L'Anse Creuse Public Schools

**Bid Package 25-01 : Flooring Replacement at Lobbestael,
Tenniswood & Yacks Elementary Schools**

ADDENDUM NO. 1

Project Name: 2024 Bond Projects – Bid Pack 25-01
Flooring Replacements Phase 1

SHEET NO.
A0-03

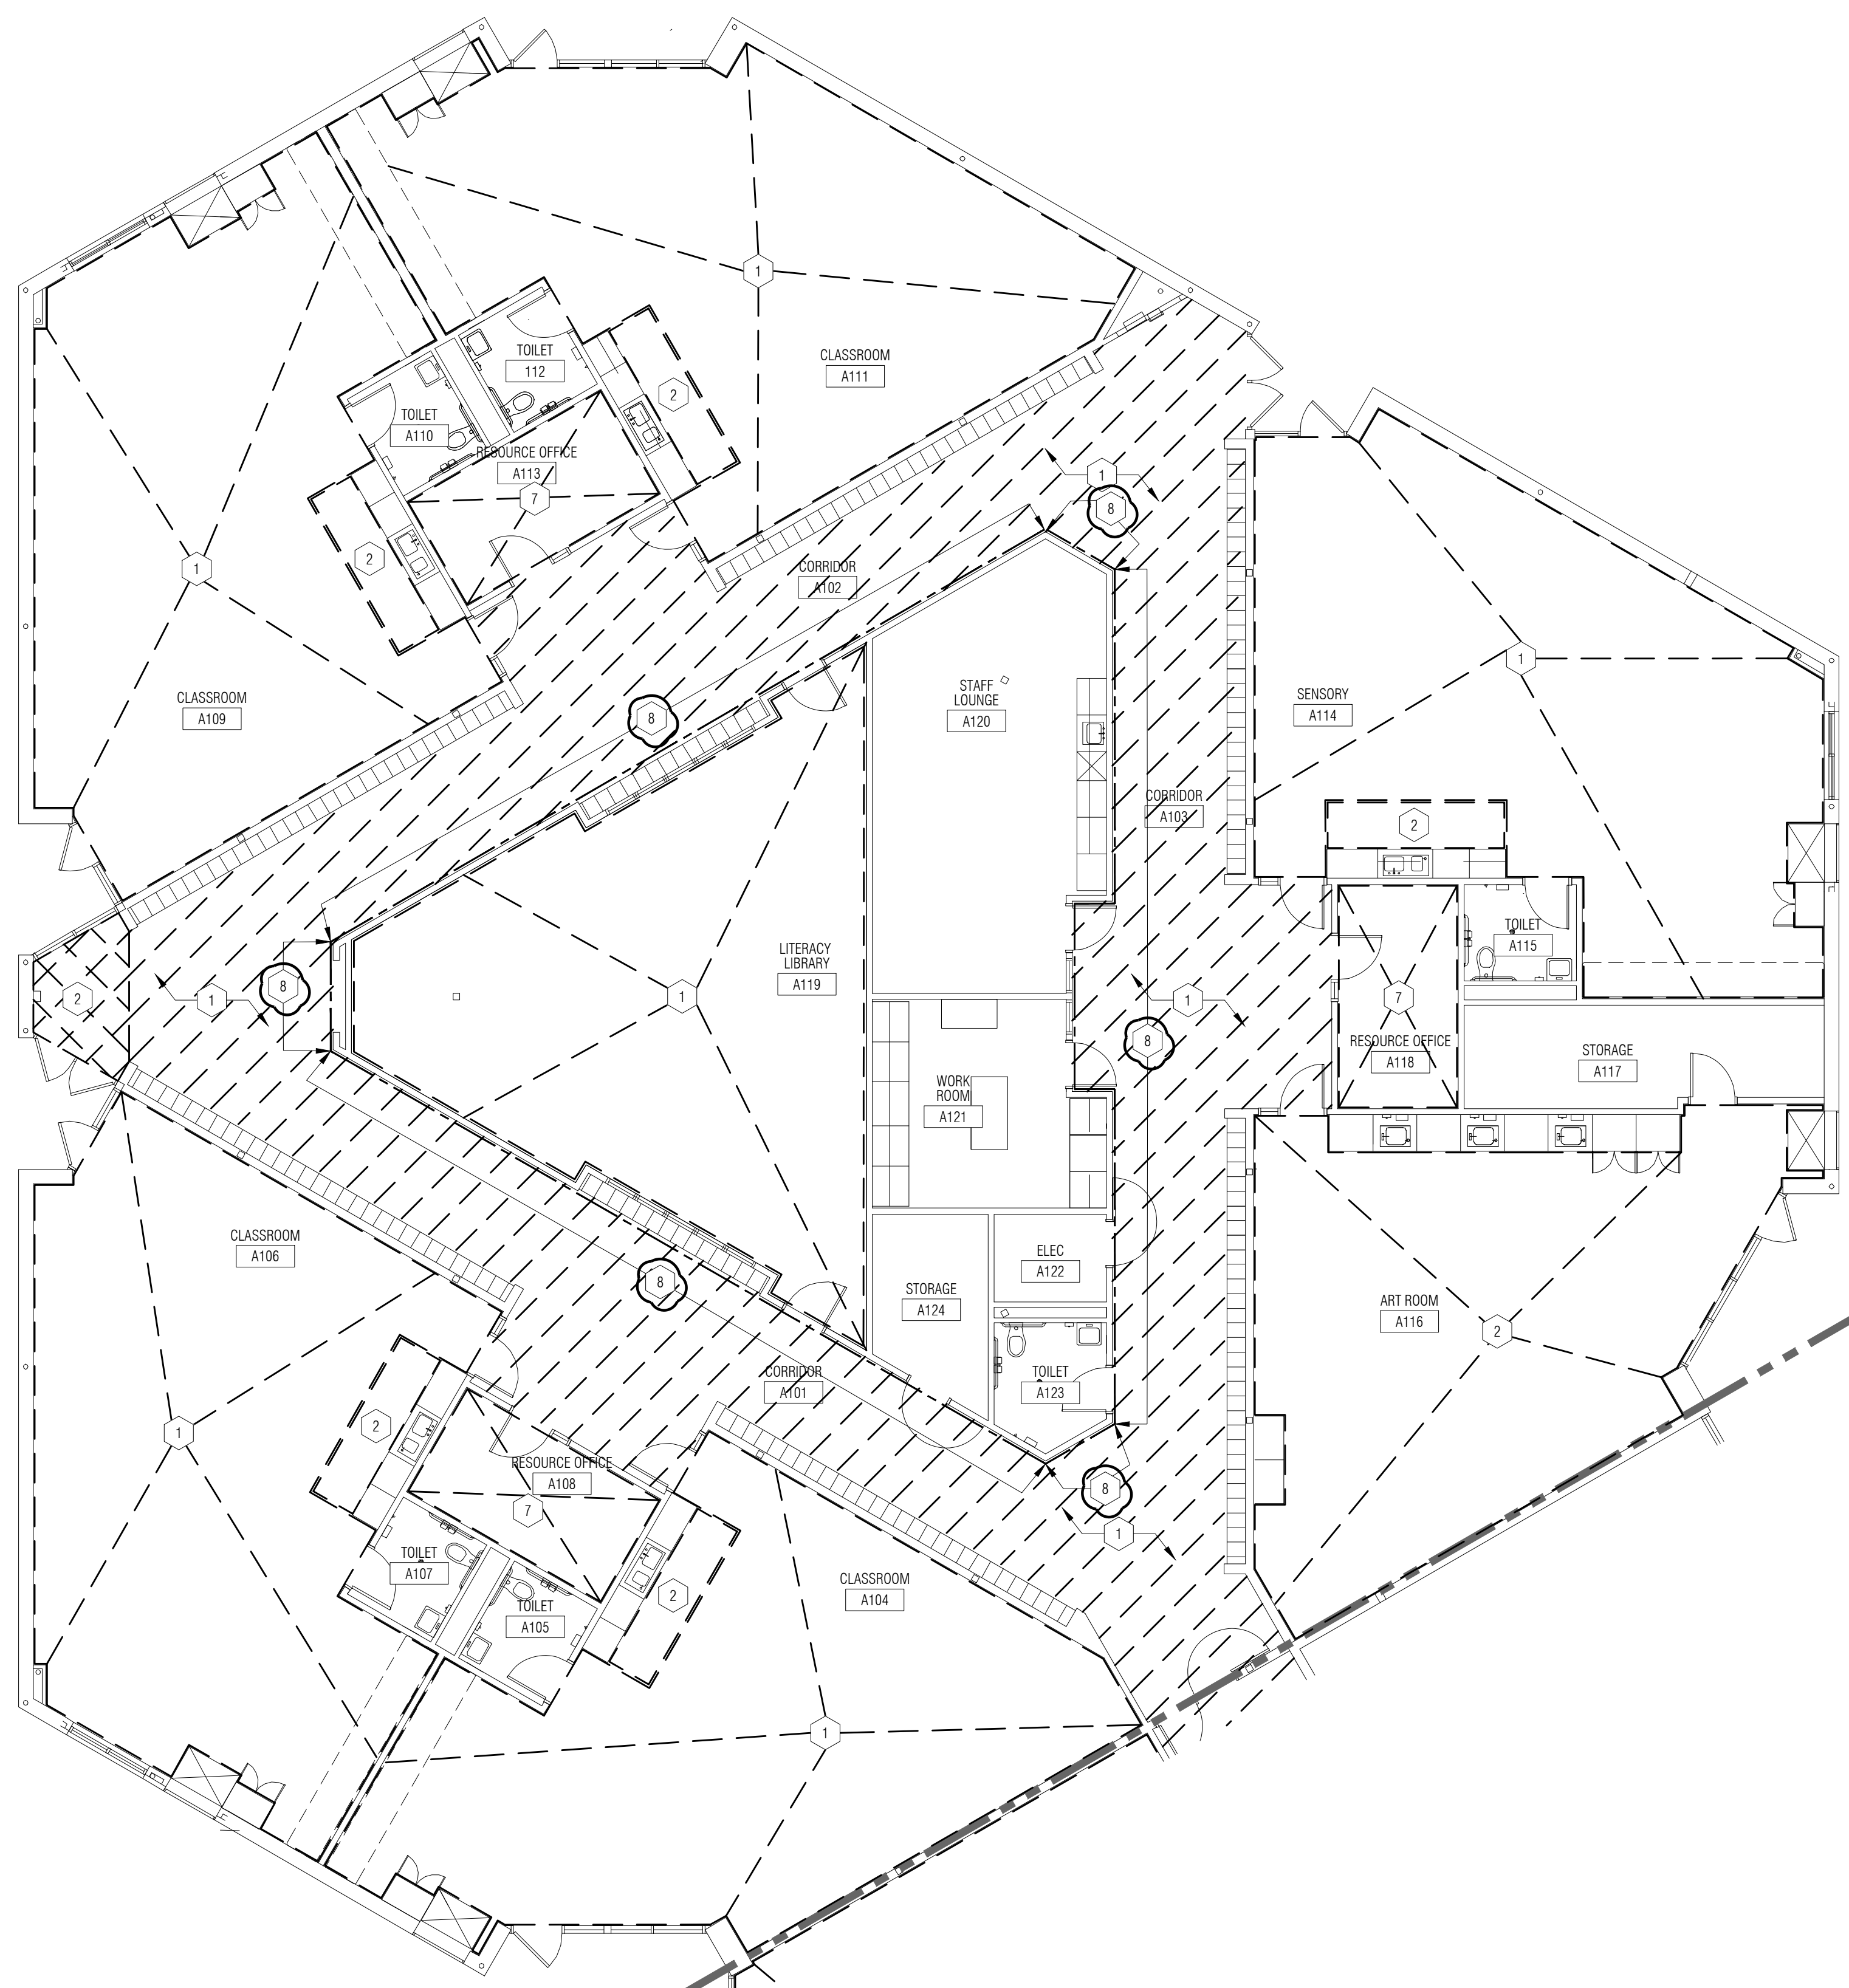
Item A1 A0-03 - Revised floor finish designations as indicated
Item A2 A0-03, A1-02, A9-02 – Added Clinic B107 to scope
Item A3 A0-03 - Revised floor transition details

SHEET NO.
A1-01

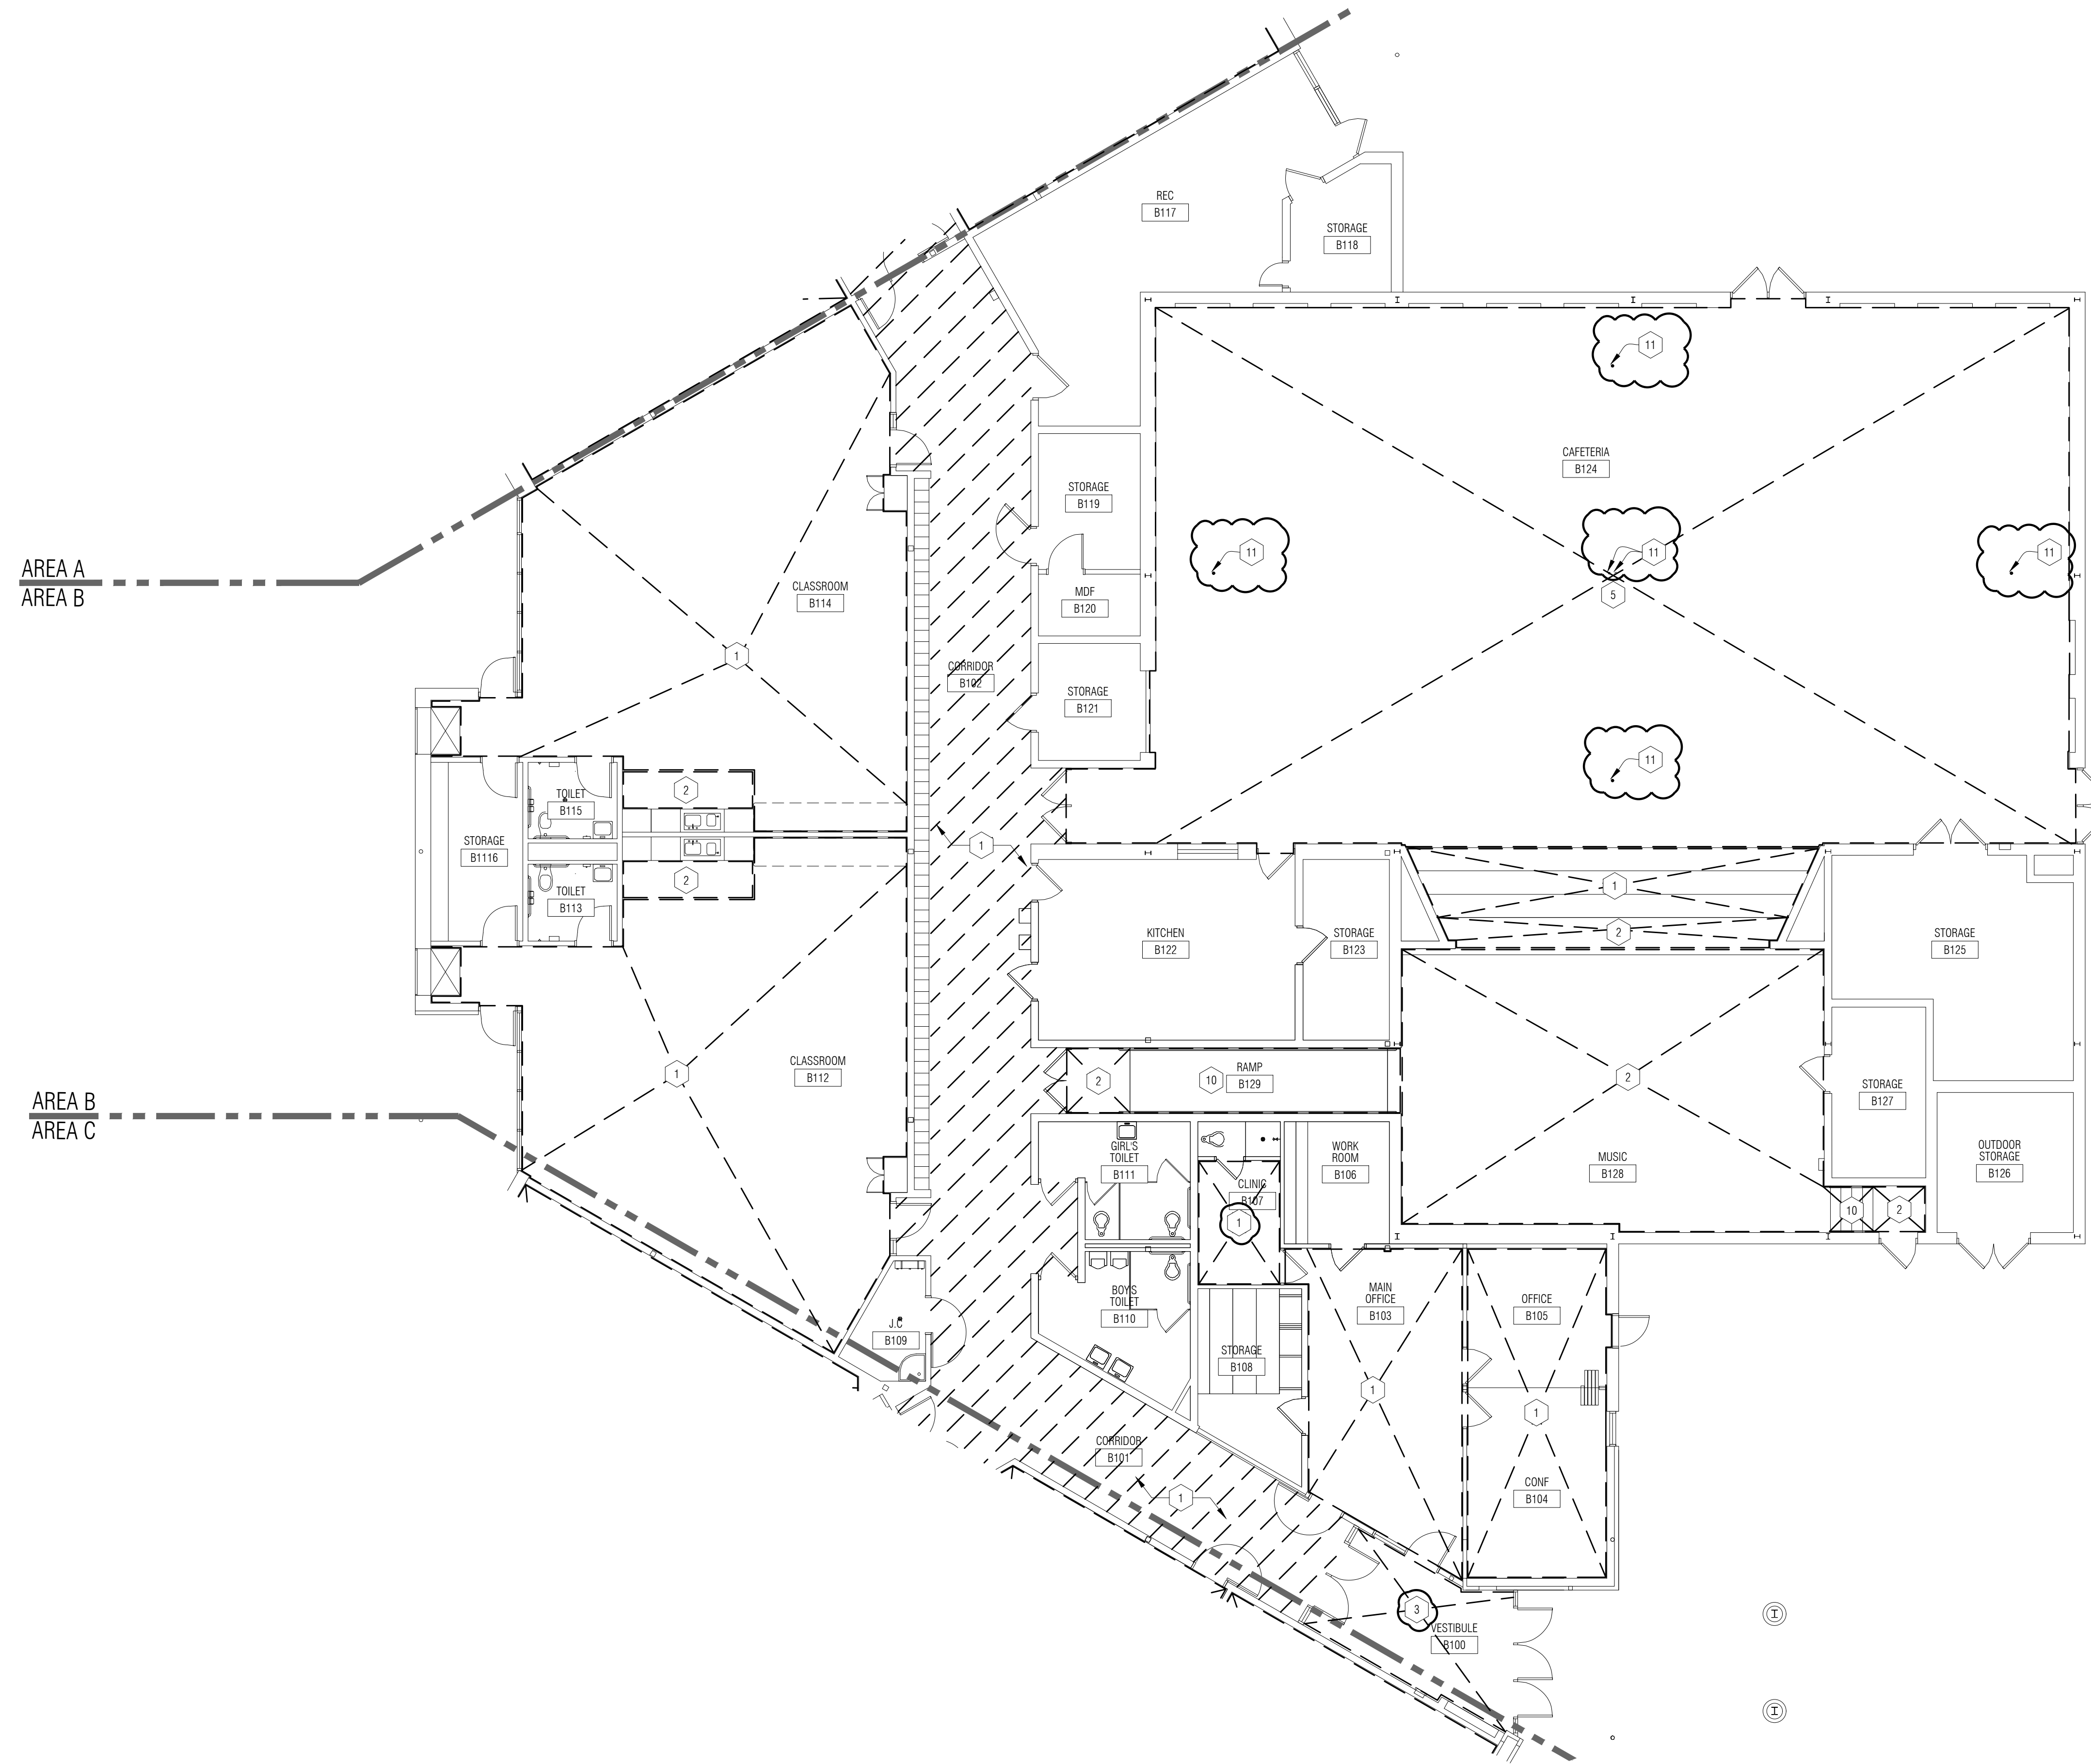
Item A4 A0-03, A9-02 – Moved stage stairs in Cafeteria from Alternate 2 to base bid.
Item A5 A1-01, A1-03 - Clarified locations of ¼ round demolition
Item A6 A1-02 – Revised demolition in vestibule to be Ceramic Tile

SHEET NO.
A1-02

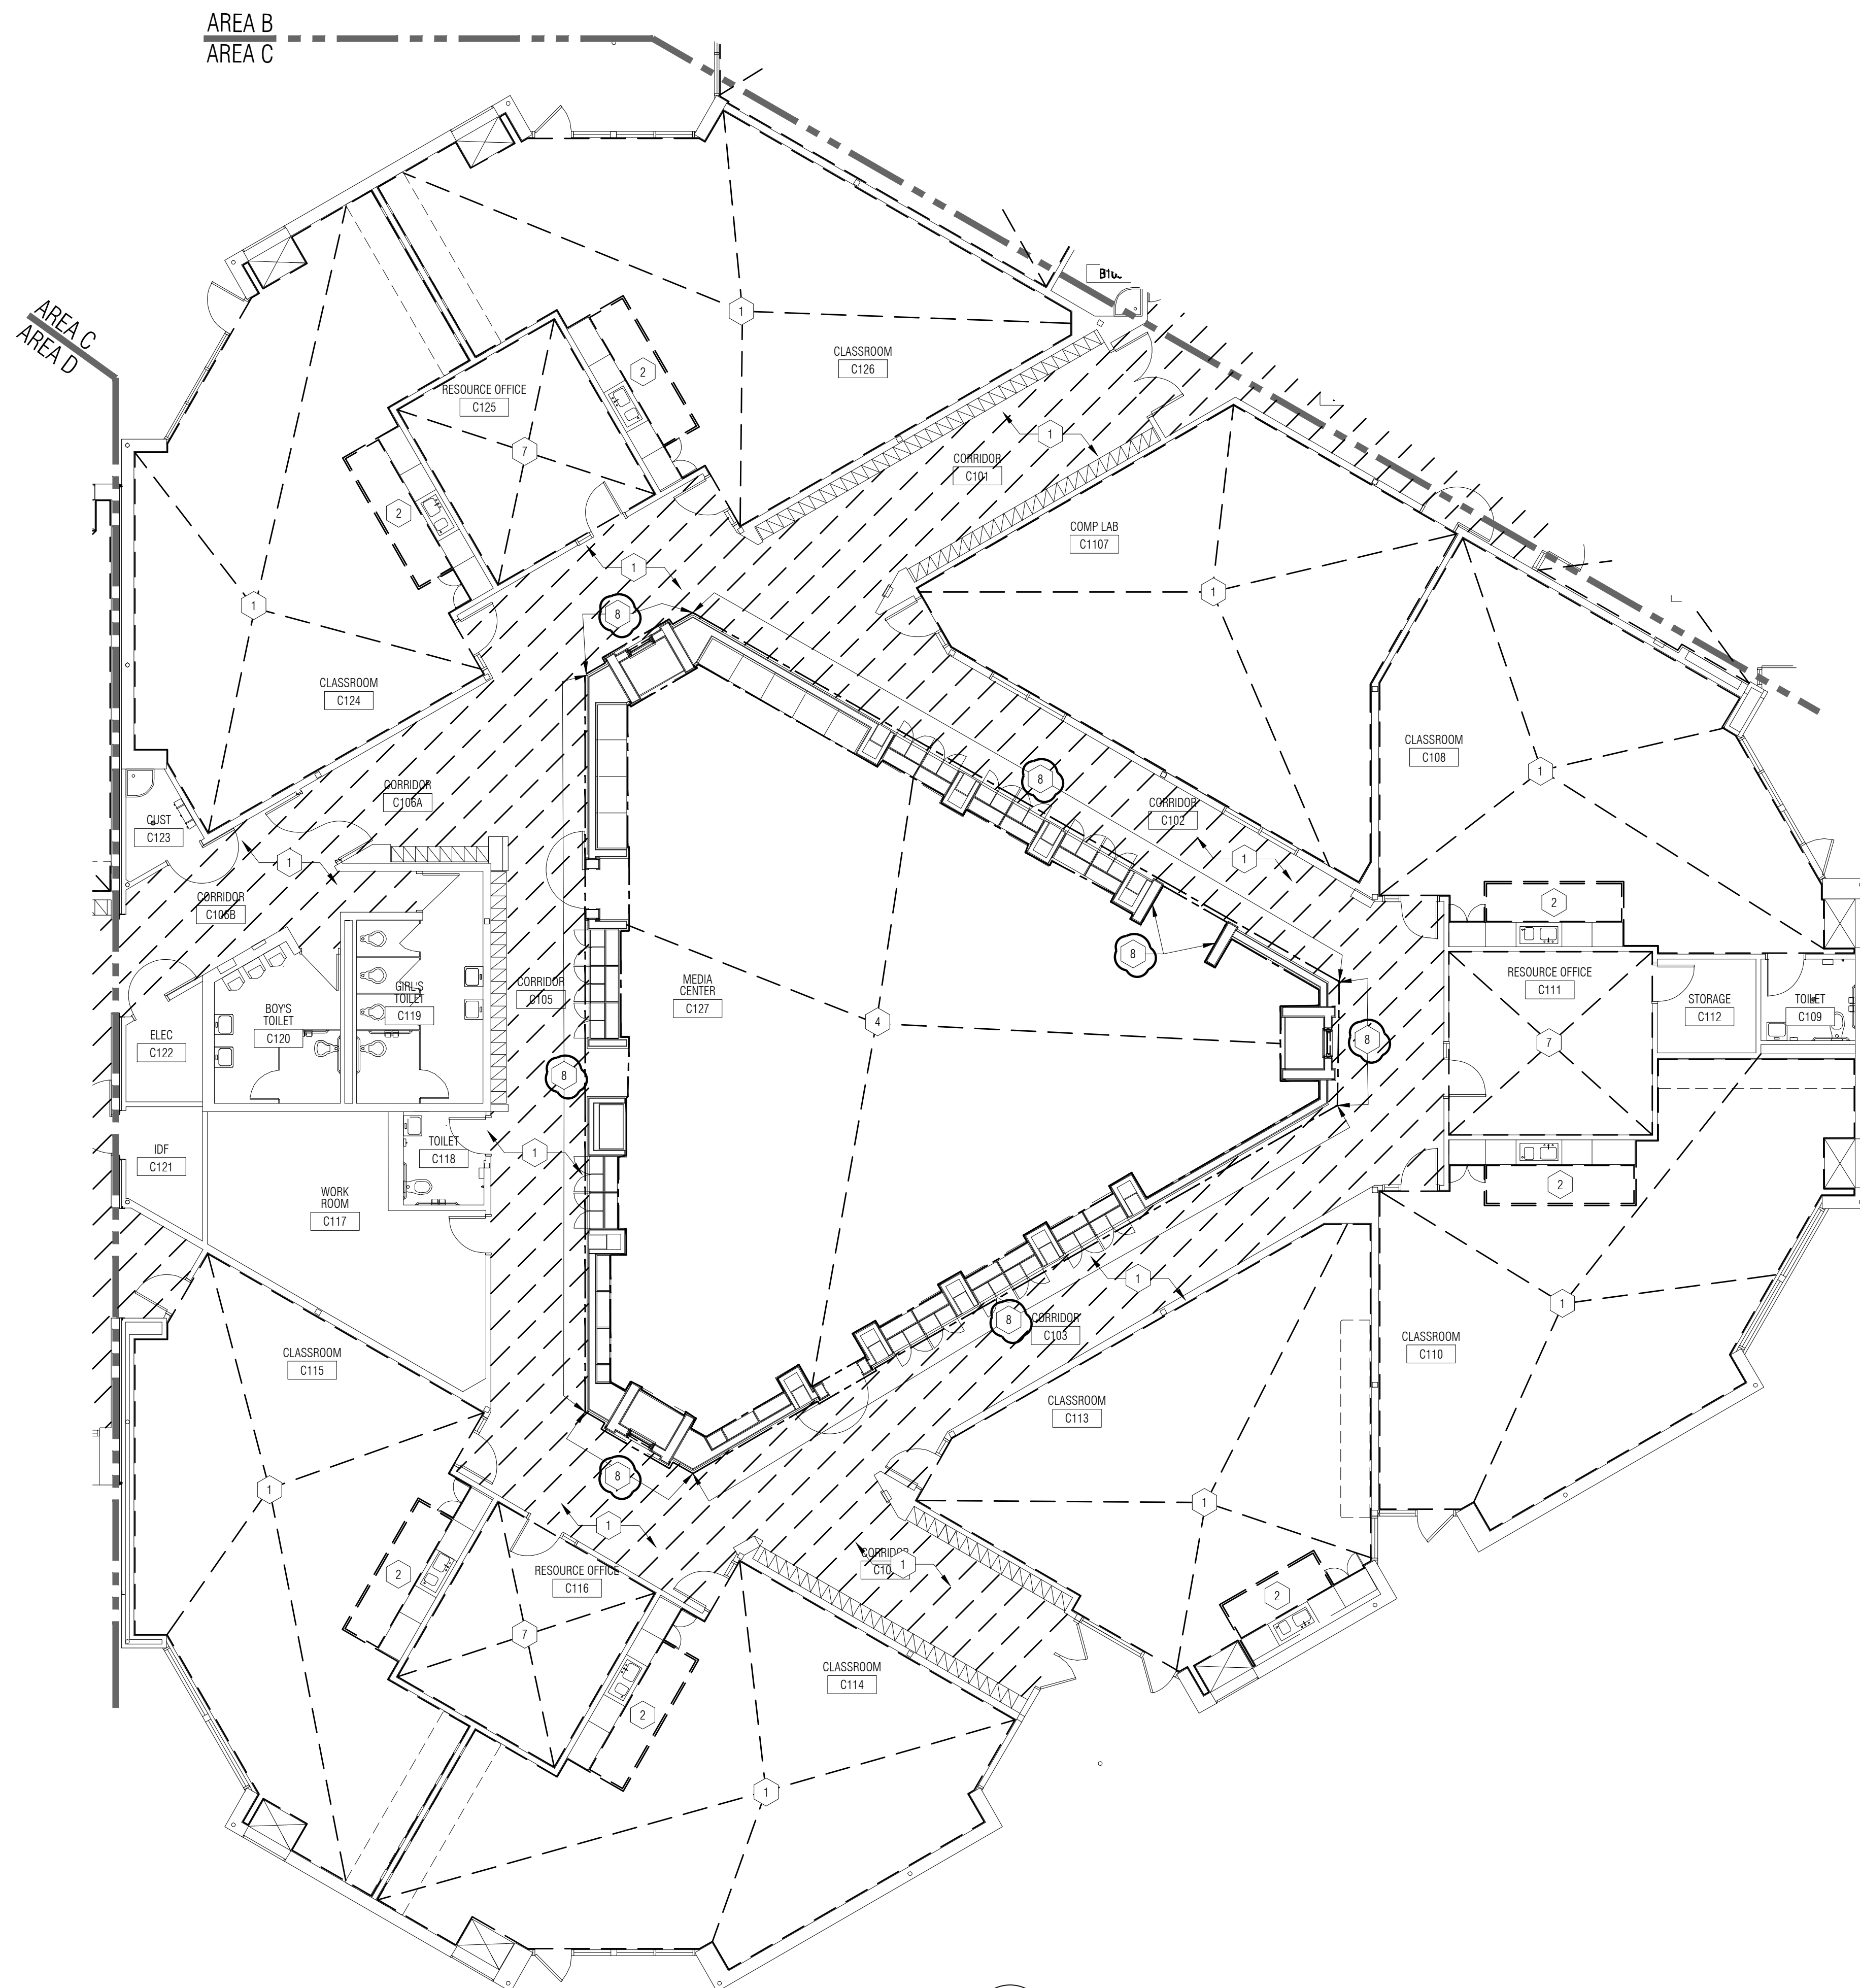
Item A7 A1-02, A9-02 – Added demolition of floor equipment sleeves from Cafeteria
Item A8 A9-01, A9-03 – Clarified locations of pattern detail and line weight in pattern detail.
